Office Action Summary

10/049,834

SCHEIBE ET AL.

DETAILED ACTION

Examiner's Marked Up Figure #3

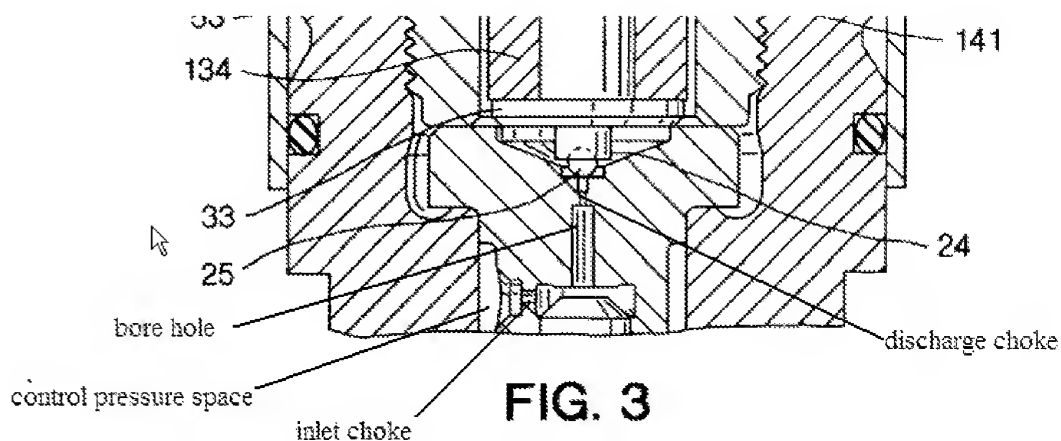
Regarding claims 2 and 22, the stop surface of the actuator is significantly larger than the sealing surface (see Fig. 3).

Regarding claims 5 and 25, the valve body is constructed as a sphere, which interacts with the opening for the passage of fluid, forming a seal (See Fig. 3).

Regarding claims 7, 9, the valve actuator (139) is essentially mushroom-shaped, the stem of the mushroom forming the valve rod and the stop surface of the actuator being an annular collar, concentrically surrounding the valve rod in the region of the mushroom cap (24) (see Fig. 3).

Regarding claims 10, 11, 27 and 28, the valve rod is guided axially movably in at least one guide bushing (134) and is disposed at a small distance from the sealing surface of the actuator (see Fig. 3).

Regarding claims 12, 13, 29 and 30 the length of the valve rod is a multiple of its diameter (see Fig. 3) and the sealing surface is formed in the end face of a disk-shaped insert part (the valve seat) (see Fig. 3) and adjoins the control pressure space on the side averted from the sealing surface.

Regarding claims 14-19, and 31-36 the insert part (also forms a stop for the valve needle) is formed in two parts with a first part, which contains an opening for the passage fluid and a discharge or outlet choke (see examiners marked up figure 3) and a second part at the control pressure space side, with a bore hole (see examiners marked up figure 3) which connects the control pressure space (see examiners marked up figure 3) with an opening for the passage of fluid. The second part contains an inlet choke (see examiners marked up figure 3) near the bore hole (see examiners marked up figure 3). The pressure space is connected with an inlet choke and the rear end of the valve needle (see examiners marked up figure 3) averted from the nozzle needle seat surface lies in the control pressure space. The pressure insert part also including an inlet choke and an outlet or discharge choke (see figure below).
